**CPUC Docket:** A.23-05-010  
**Exhibit Number:** TURN-05-E  
**Witness:** Jalal Awan

**PREPARED TESTIMONY OF  
JALAL AWAN**

**ADDRESSING SOUTHERN CALIFORNIA EDISON’S TY 2025 GENERAL  
RATE CASE DISTRIBUTION RELATED ISSUES AS IDENTIFIED IN  
EXHIBIT SCE-02 (‘GRID ACTIVITIES’)**

**THE UTILITY REFORM NETWORK**

Figure 7 Recorded and Forecasted Costs for Substation Circuit Breaker Replacement Program vs. Number of CBs replaced.

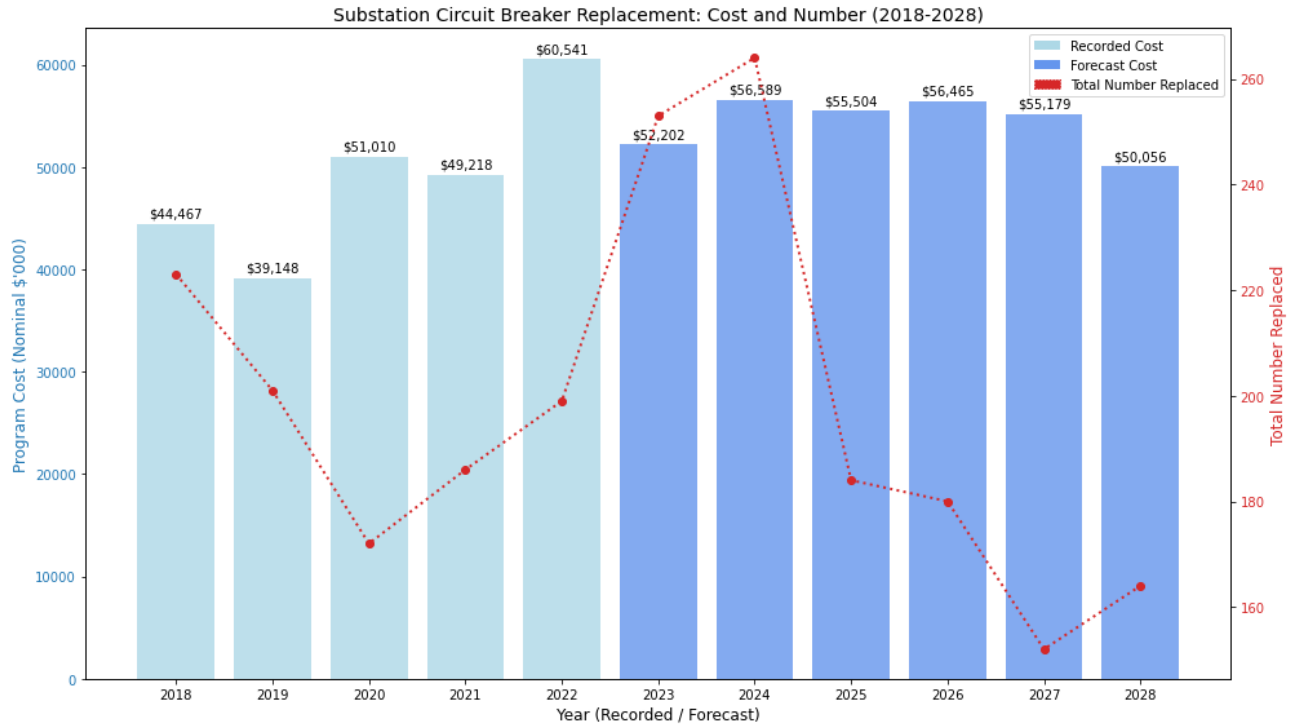
The higher costs incurred on the relatively low number of replacements is cited to be driven by “increased material and labor costs.”<sup>31</sup> SCE notes that: “...The CPUC authorized \$43.372 m in the 2021 GRC decision for replacement of 205 CBs. SCE incurred \$49.218 m for the Circuit Breaker Replacement Program in 2021 and replaced 187 CBs. This variance was driven by increased material and labor costs in 2021...”<sup>32</sup>

**TURN recommends SCE adopt a more focused strategy for circuit breaker replacements - with an authorized program cost of \$294.7 (Nominal) compared to SCE’s estimated forecast of \$325.9m (Nominal) – and targeting only those 1088 circuit breakers rated “Poor” or “Very Poor” per the Health Index against SCE’s plan of 1,197 replacements at a rate of 200 per year. TURN further calls for a detailed reanalysis of unit costs and proposes using exact voltage classes for circuit breakers, ranging from 4 kV to 500 kV, to enhance forecast precision and transparency as opposed to the two broader categories of circuit breakers by voltage class currently used.**

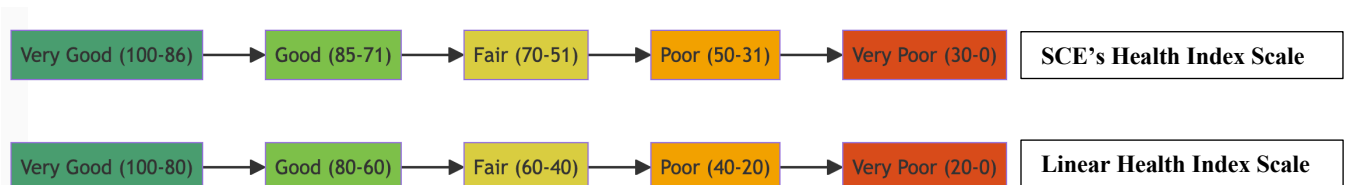
The correct methodology entails calculating the mean of the project totals for a specific voltage level and then multiplying this average by the escalation factor (once) to achieve the average

escalated cost. Based on above, and per SCE’s calculation of forecasted costs across two voltage classes (2.4 – 115kV and 220-500kV), TURN vs. SCE estimates are as follows:

TURN proposes using actual costs, by CB voltage levels, to calculate program forecasts – rather than averaging across two broader categories as shown above, and as used by SCE.

- o Related to above, unit cost analysis needs to be confirmed / re-done. Moreover, SCE should detail the precise voltage classes, such as 4 - 16 kV, 33 kV, 66 kV, 115 kV, 220 kV, 13.8 kV, and 500 kV, for their circuit breaker forecasts for accuracy and transparency, instead of voltage class by two broad categories.

Figure 9 Circuit Breaker Health Index data (2018-2022)

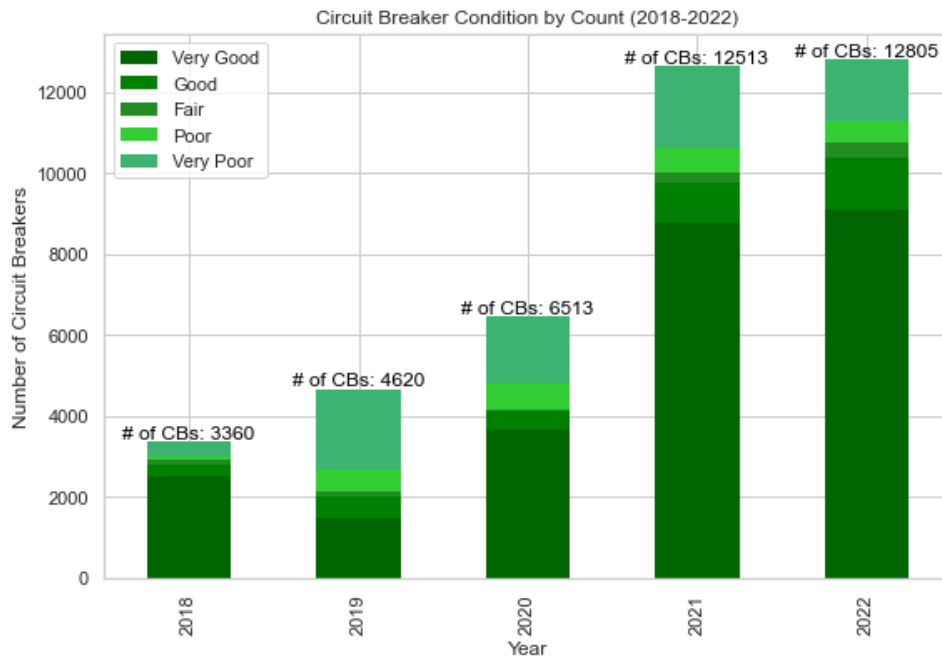
SCE fails to provide a scoring or a scoring rubric to provide an empirical basis for its Health Index score, or historical data suggesting that SCE’s ”Poor” or “Very poor” classifications

SCE's Health Index is questionable as it allocates half the scale to “Poor” or “Very poor” without disclosing the scoring distribution or empirical evidence for such weighting. This opacity raises concerns about the index's predictive validity for equipment failure and the justification for replacement decisions.

- SCE must substantiate the accuracy of its non-linear health index by providing evidence of correct predictions—where equipment deemed likely to fail did indeed fail—using a clear true versus false positive analysis. This applies to other sections of testimony where the Health Index scale is used.

- o SCE's Health Index, used to determine the condition of circuit breakers, disproportionately assigns half its scale to “Poor” or “Very poor”. For a more accurate reflection of equipment conditions and to guide replacement decisions effectively, SCE should revise its Health Index to distribute scoring more evenly across categories (as quintiles) and provide transparent, empirical evidence for the weightings and classifications behind the Health Index scale.

***Table V-22***  
***Circuit Breakers by Health Condition***  
***as of 2022 Year End***

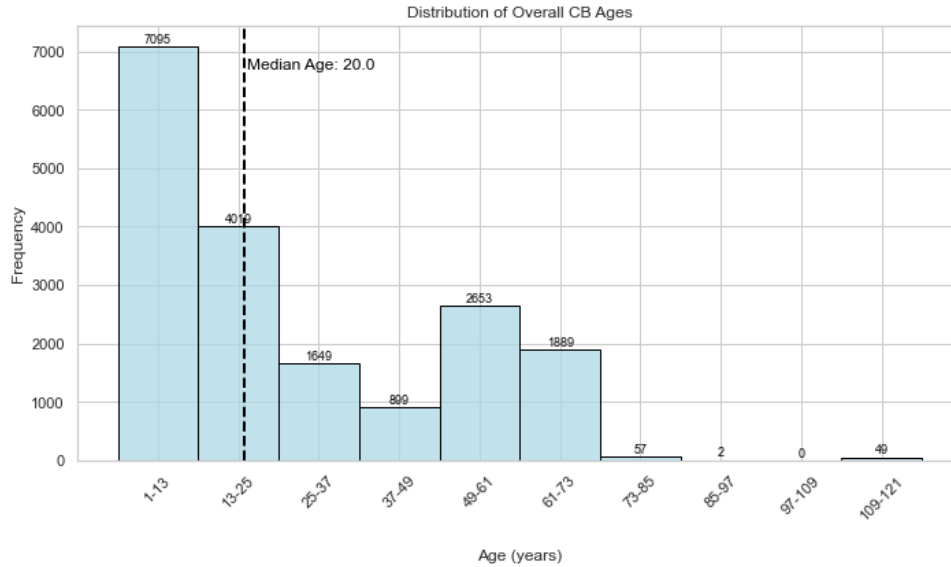
Historical and proposed replacement of CBs shows that CB health condition data in Table V-22 is not uniformly considered in replacement. In fact, recorded and forecasted installations show CBs in the ‘Very Good’ to ‘Fair’ health condition being replaced without any justification. For example, 44 historical and 109 proposed installations were found to be in “Very Good”, “Good”, or “Fair” condition – undermining SCE’s reliance on health condition of CBs for replacement.

Of these, 4-16kV, 33kV and 66kV CBs seem to be of the most concern, due to number of CBs and relatively high median age (see Appendix 3a). TURN acknowledges that age is an important factor, albeit not the only factor, to determine Health Index.

- **Based on our review, TURN proposes to replace CBs in “Poor” and “Very poor” condition per SCE’s Health Index of 1088 CBs from 2023-2028 at an average annual rate of 181 CBs per year – as opposed to SCE’s proposed 1197 CB replacement at 200 replacements per year.<sup>43</sup> The proposed replacement results in an authorized program cost of \$294.7m (Nominal) compared to SCE’s estimated forecast of \$325.9m (Nominal) from 2023-2028.**
- **TURN proposes to exclude all CBs in “Very Good” to “Fair” condition for this GRC.**
  - o SCE should refine its replacement strategy to exclusively target circuit breakers in “Poor” or “Very poor” condition, as per revised Health Index. This approach

Figure 10 Inter-Quartile Ranges for replaced Circuit Breakers with labeled 50<sup>th</sup> percentile values

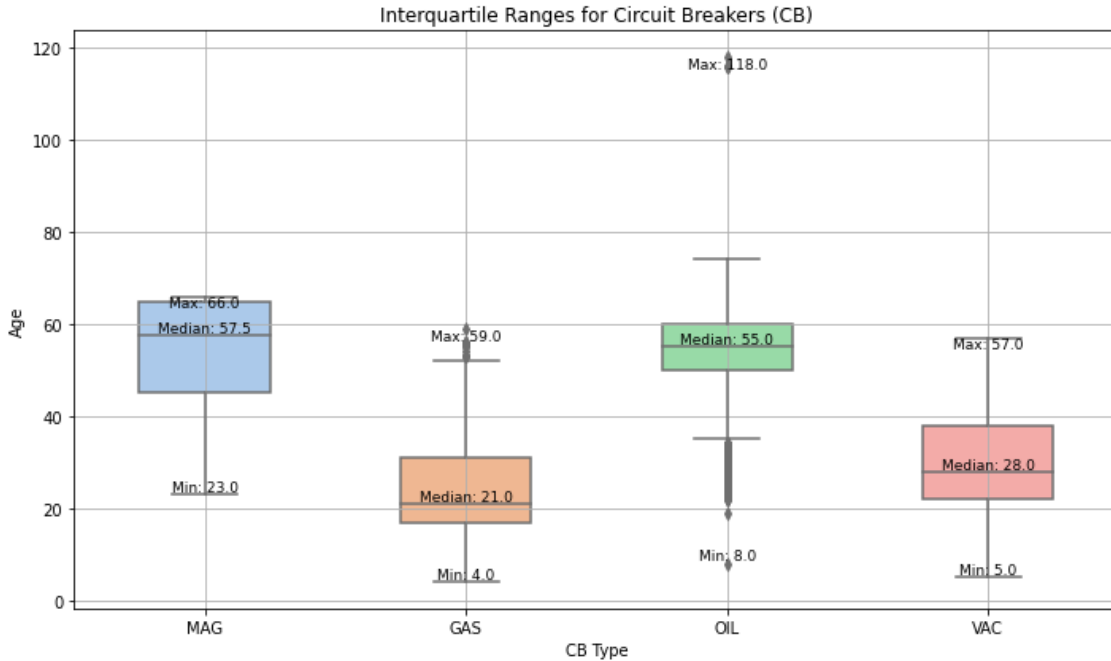
TURN’s contention is that modeled mean time to failure for each CB type should be evaluated against Original Equipment Manufacturer (OEM) recommended mean time to failure to identify variation in observed vs. OEM-suggested failure rates. In response to TURN’s DR, SCE suggested that: “...To SCE’s knowledge, manufacturers typically do not provide a recommendation for a MTTR, MTBF or EUL parameters. SCE typically provides the appropriate design standard for expected design life to the OEM. According to current industry standards, the design life expectancy for circuit breakers and transformers is 30 years...”

Yet, the following charts show large variance from 30 year end of useful life (EUL) suggested by SCE, implying that this cycle of infrastructure replacement will continue unless the EUL estimates are empirically established based on current, installed equipment age and performance status. While this is not in-scope for TURN’s testimony, the currently authorized depreciation life for distribution station equipment (i.e. 65 years), provides an additional data point to challenge the 30 year EUL provided by SCE.

- SCE's reliance on Weibull models for justifying equipment replacements should be disregarded for forecasting purposes due to its conflation of replacement rates with actual failure rates and the questionable validity of its underlying assumptions.

Figure 12 Inter-Quartile Range (IQR) for replaced transformers from SCE’s Weibull Reliability analysis

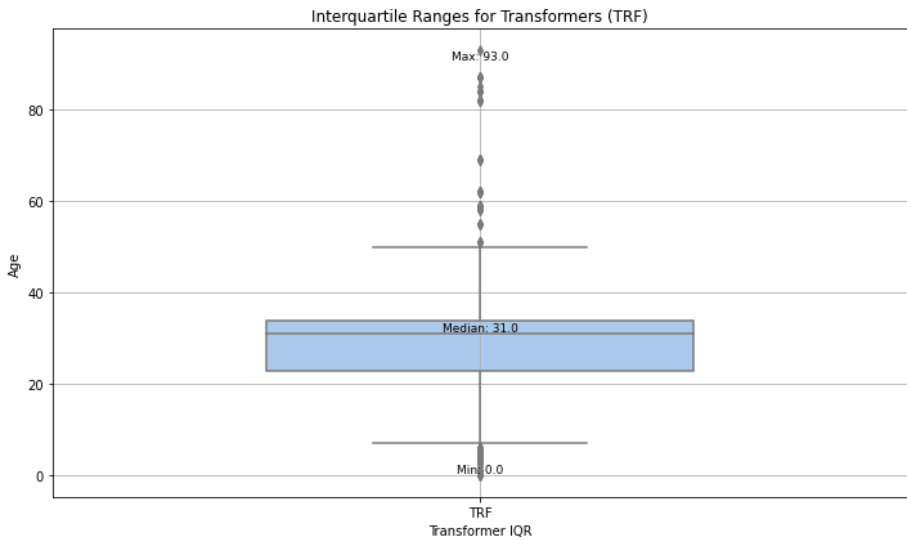
For Weibull analysis, the median age of transformers historically replaced “for all causes” is 31 years, with a large variation (0-90+ years) as shown below:

Literature on power transformer failure analysis suggests that in order to observe a large number of failures per year a much larger power transformer fleet is required than is often owned by one

Figure 13 Total Installation counts forecast (n=213) by year and health status

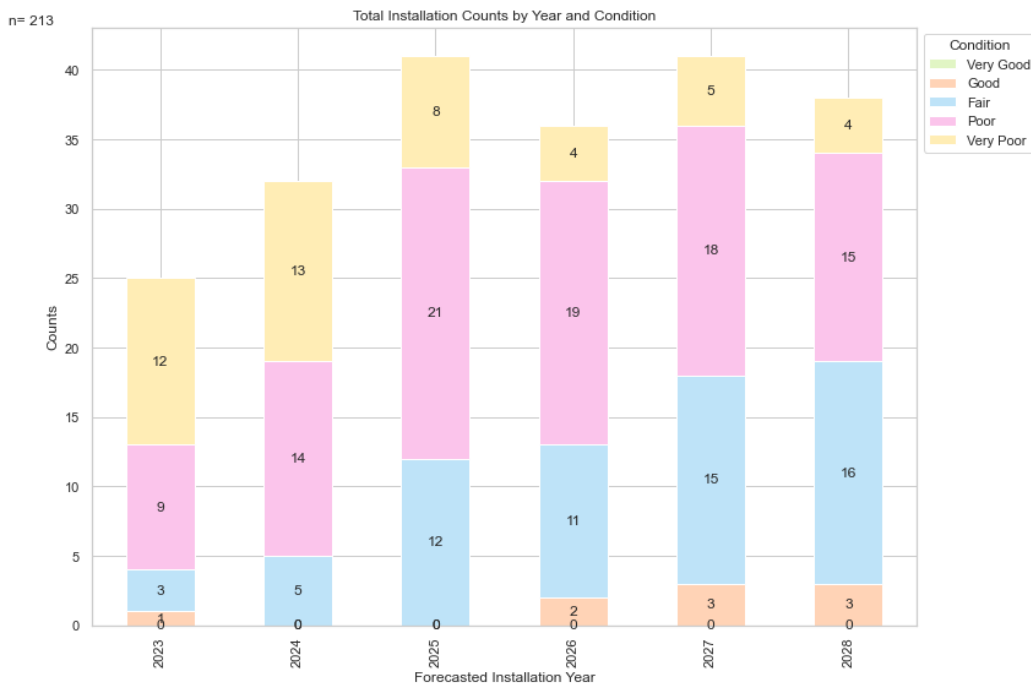
utility<sup>44</sup>. TURN’s analysis suggests A-Bank and B-Bank transformers have a median age of 12 and 24 years respectively – and therefore generally not old (see Appendix 4a). Again, TURN finds that the total forecasted installations (n=298) per data provided by SCE for 2023-2028 replacements includes a large number (n=94) of Transformers in ‘Fair’ and/or ‘Good’ condition, even according to the company’s non-linear scale which exaggerates ”Poor” or “Very poor” counts as shown below<sup>45</sup>:

Figure 17 2013-2022 SAIDI trend from SCE's 2022 Annual Reliability Road

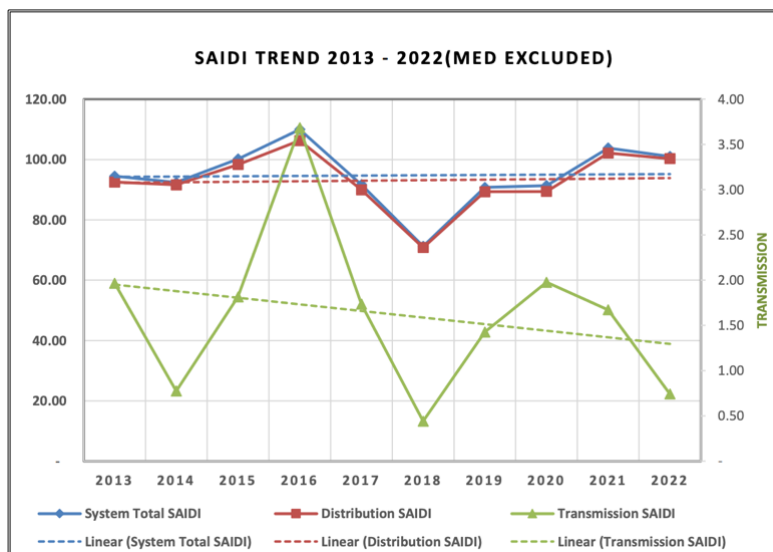
In discussing its distribution infrastructure replacement drivers<sup>51</sup>, SCE presents safety, service reliability, capacity needs, and aging infrastructure as primary drivers of its distribution infrastructure replacement. In the SCE GRC Workshop Presentation as well as its GRC application, SCE emphasizes its need for massive infrastructure replacement capital expense by showing worsening trends of SAIDI / SAIFI numbers.<sup>52</sup>

TURN finds that, from SCE’s 2022 Annual Reliability Report, these trends may have been a direct causal effect of SAIDI / SAIFI metrics worsening at the Transmission Level, for any number of reasons unrelated to aging distribution infrastructure. In general, based on protection coordination with downstream devices, a fault on the transmission

Figure 18 Nominal program costs (Recorded 2014-2022 vs. Forecasted 2023-2028) for Overhead Conductor Program (OCP).<sup>60</sup>

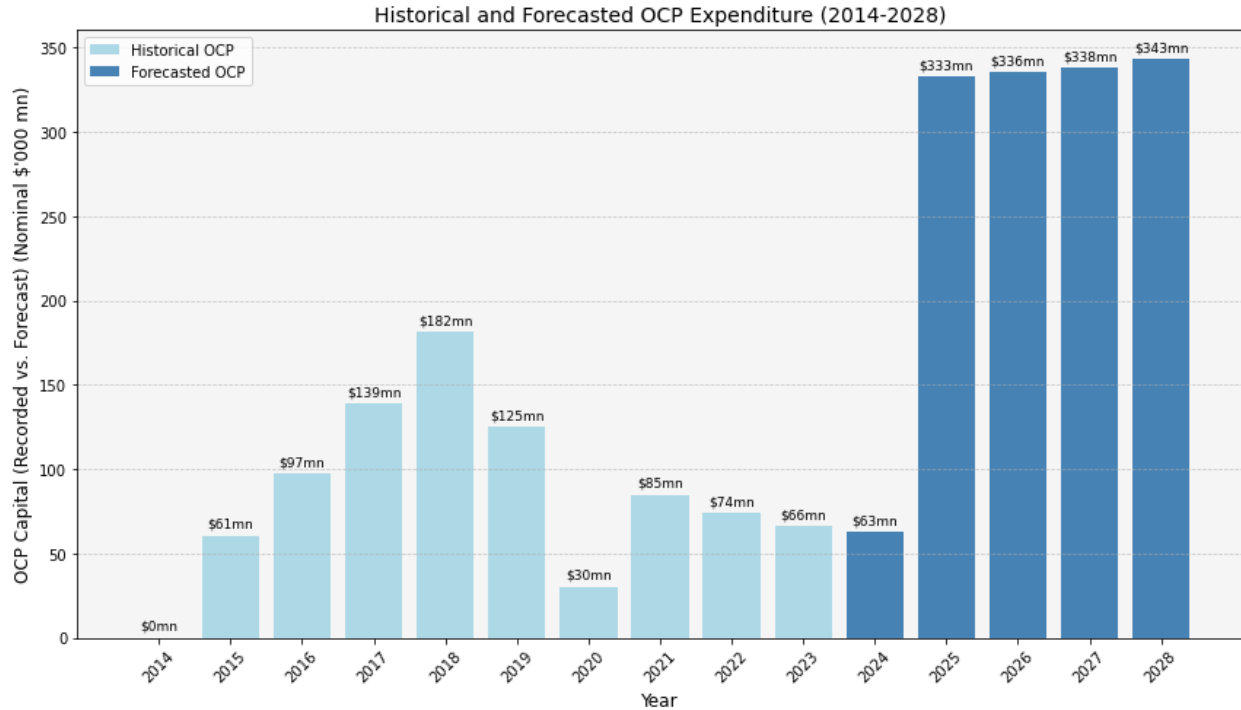
OCP had a budget over-run of \$12m (nominal) based on 2021 authorized vs. recorded capital expenses.<sup>61</sup> In the 2021 General Rate Case (GRC) Decision, it was established that SCE's implementation of 3,750 circuit miles of covered conductor is the most extensive among California Investor-Owned Utilities. Moreover, the Decision noted SCE's insufficient explanation of the Public Safety Power Shutoff (PSPS) benefits resulting from this deployment. Despite the significant installation, risks of utility-caused ignitions persist even in areas with covered conductors.<sup>62</sup>

**burdensome and, in all likelihood, not achieve the projected safety and reliability benefits. In case the entire program is not rejected, we propose approving only small-gauge wire replacements (~634 miles) within the OCP due to their higher failure probability. We further recommend rejecting SCE’s planned replacements using bare conductors—117 miles in 2023 and 91 miles in 2024—based on SCE’s own showing of reduced bare conductor benefits. While we acknowledge the safety risks of energized wire-down events, TURN points to SCE’s admission of not tracking Serious Injury and Fatality (SIF) data by circuit segment, which casts doubt on the effectiveness of the ML model-based segments in reducing SIF or potential SIF incidents. TURN’s proposal recommends authorizing \$396.5m (Nominal) against SCE’s proposal of \$1.4bn (Nominal) for the program.**

*Figure 21 Historical Reliability (No. of Interruptions and CMI) of circuit Miles proposed to be replaced by covered conductor is already improving, thanks to other ratepayer funded mitigation programs.*

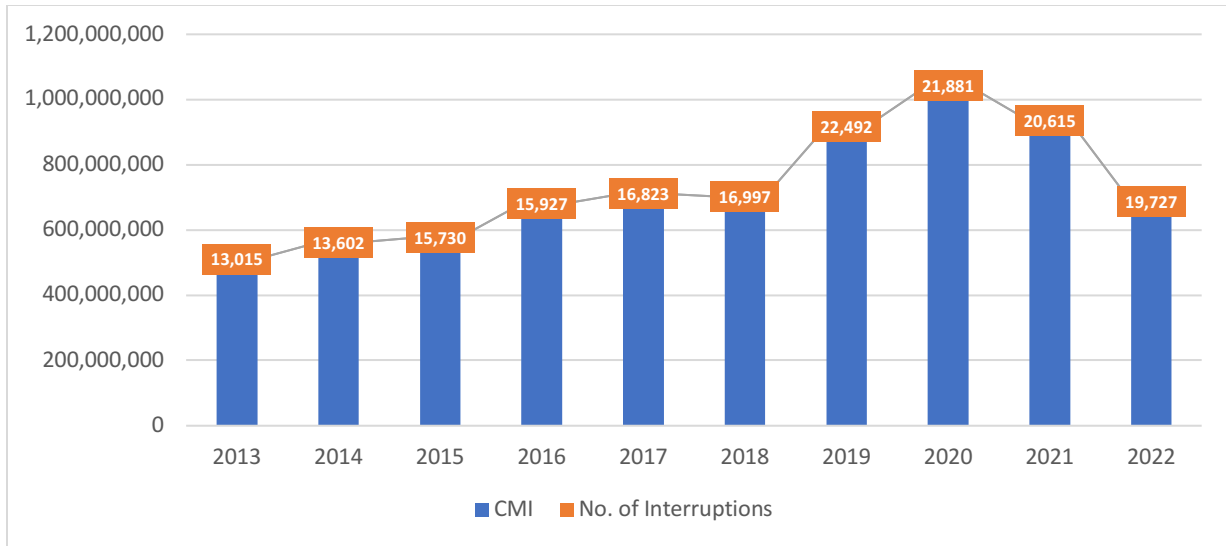
TURN notes that historical reliability of circuit segments / circuit miles targeted by the program has already been improving with existing rate-payer funded programs.<sup>69</sup> SCE states that :  
“...While IR is driven by safety and reliability concerns, it can also provide an opportunity to address capacity to a degree as well...”<sup>70</sup> For capacity, OH conductor would require bigger gauge cable to achieve the same level of capacity due to ampacity difference between bare vs. insulated cable.

Figure 23 OCP Program Scope (Small vs. Big Wire)<sup>75 76</sup>

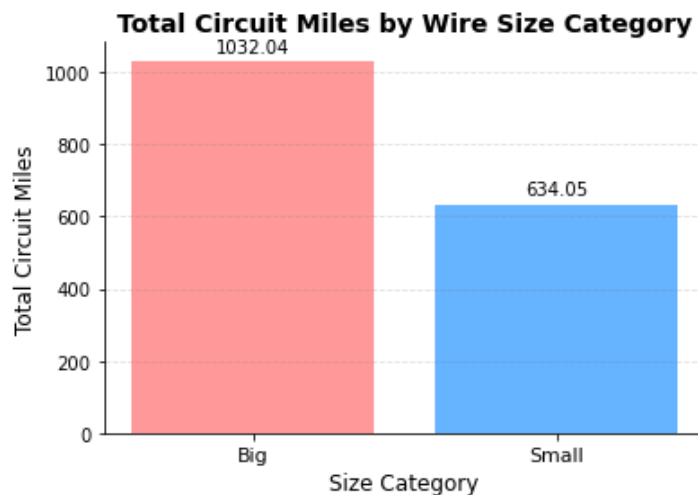
SCE's scope for its Overhead Conductor Program (OCP) has expanded from its RAMP 2022 filing to the General Rate Case (GRC) to include larger gauge wires in addition to the previously targeted small-gauge wires, without an accompanying tranche-level analysis of larger gauge wires and their associated RSE scores. SPD identifies this as its first key observation in its response to SCE’s RSE scoring for the Contact with Energized Equipment (CEE) Risk, stating that “SCE excluded reliability and financial consequences from their calculation of risk scores” and that “SCE’s tranche analysis is not in compliance with the (S-MAP) Settlement Agreement requirement (with respect to the level of granularity expected for the CEE Risk)”.<sup>73</sup>

The OH Conductor model utilized by SCE employs Random Forest, a machine learning technique, to predict the probability of failure for distribution primary overhead conductors predicting 1,680 circuit miles of (small and big gauge) bare conductor to be replaced with covered conductor.<sup>74</sup>

Figure 24 Large / Small / Unknown Gauge – related wire-down events by Primary Driver (2013-2022)<sup>78</sup>

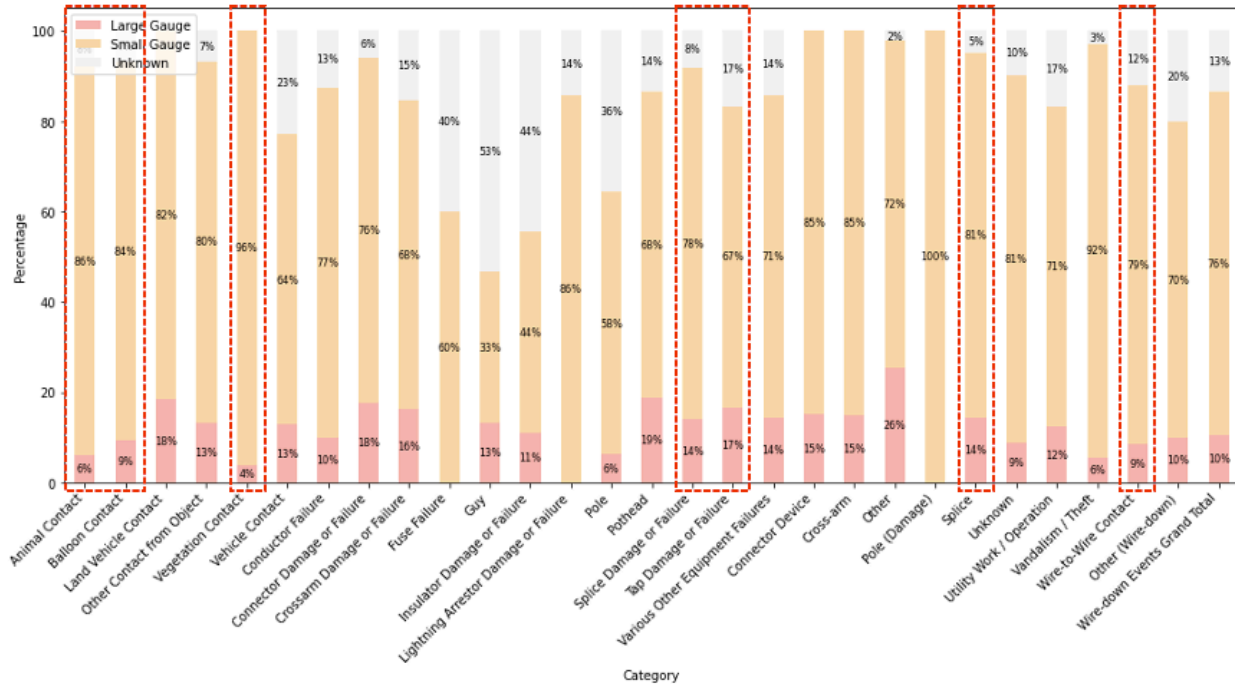
TURN argues that covered conductor is only justified for targeted replacement of small gauge wire as reflected from analysis of SCE’s data historical wire-down events below. Covered conductor is ‘effective’ in highlighted categories, per Covered Conductor Compendium, pg. 40, reflecting its efficacy for a limited number of primarily small-gauge wire related outages.<sup>77</sup>
